STAFF RECOMMENDATION 1719 5th Avenue North March 19, 2014

Application: Partial demolition, Violation
District: Salemtown Neighborhood Conservation Zoning Overlay
Council District: 19
Map and Parcel Number: 08108046100
Applicant: Derek Hoevel, property owner
Project Lead: Robin Zeigler, robin.zeigler@nashville.gov

<p>Description of Project: The applicant seeks approval for work done without a preservation permit and for additional alterations to this contributing building.</p> <p>Recommendation Summary: Staff recommends disapproval of the alteration of the primary entrance dimensions and the front addition based on the fact that it does not meet sections V.B.1, II.B.1.e and 2.a and f and further recommends reconstruction of the original roof and porch roof forms.</p>	<p>Attachments A: Photographs B: Site Plan D: Elevations</p>
---	--

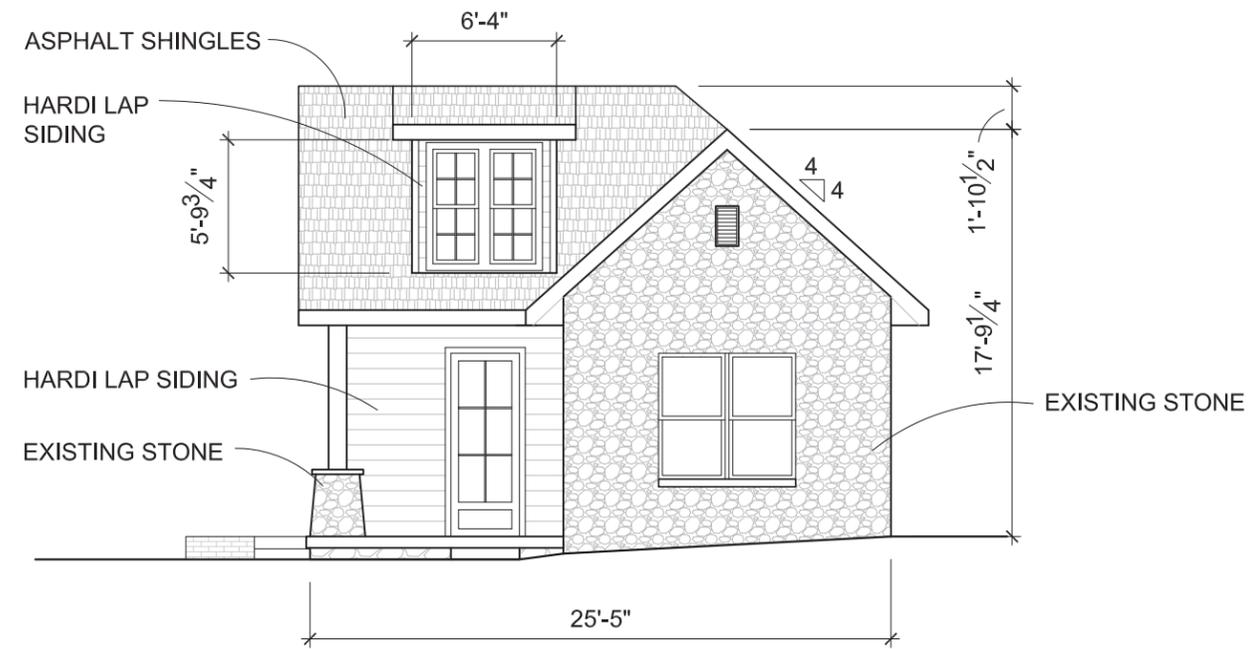
Location & Removability: The project includes a front addition that contains a front dormer and the reconfiguration of the roofline. This portion of the house is now almost two feet taller (1' 10 ½") than it was originally. The front of the building is not an appropriate location for additions, as it changes the historic character of the building. Generally, additions should be at the rear and in some cases could be located at the side of a historic building. With the exception of replacing missing porches, front additions have not been approved on historic buildings by the Commission in the past. In addition, the front addition alters the existing roofline so it is not removable without altering the form of the house. The project does not meet section II.B.2.a and f.

Roof form: The front addition alters the original roof form of a cross-gable with a shed roof porch to a cross-gable with a shed roof dormer and a recessed porch. Since this alteration of a character defining feature of the house dramatically changes the original roof form as seen from the street, it is inappropriate and does not meet section II.B.1.e.

Staff recommends that the front addition be removed, the original roof and porch form be restored, and the entrance retain its current dimensions.

5th Avenue Elevations

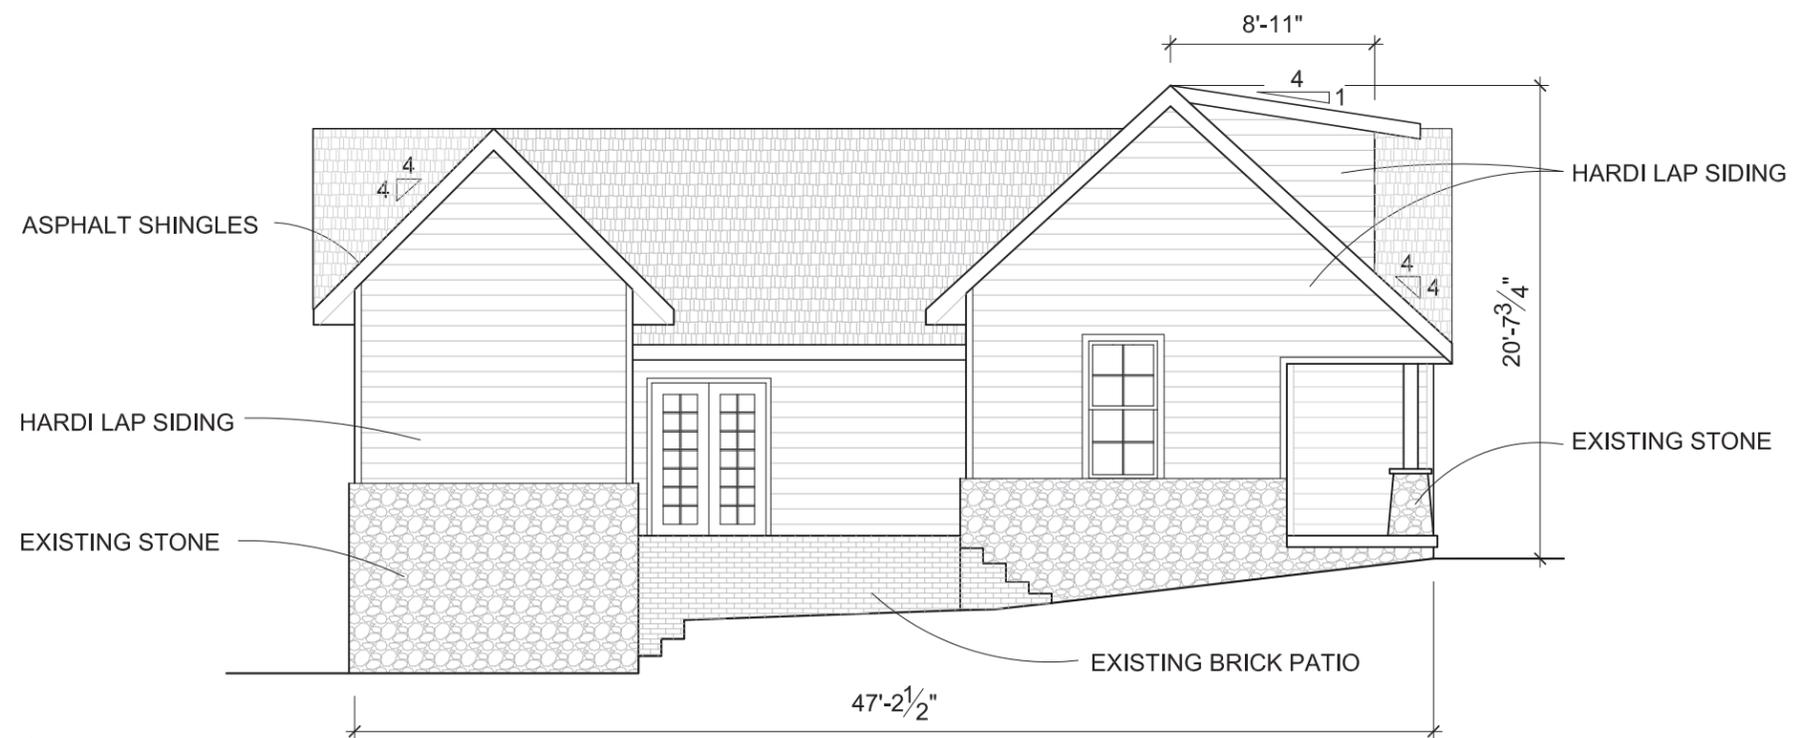
Recommendation: Staff recommends disapproval of the alteration of the primary entrance dimensions and the front addition based on the fact that it does not meet sections V.B.1, II.B.1.e and 2.a and f and further recommends reconstruction of the original roof and porch roof forms.
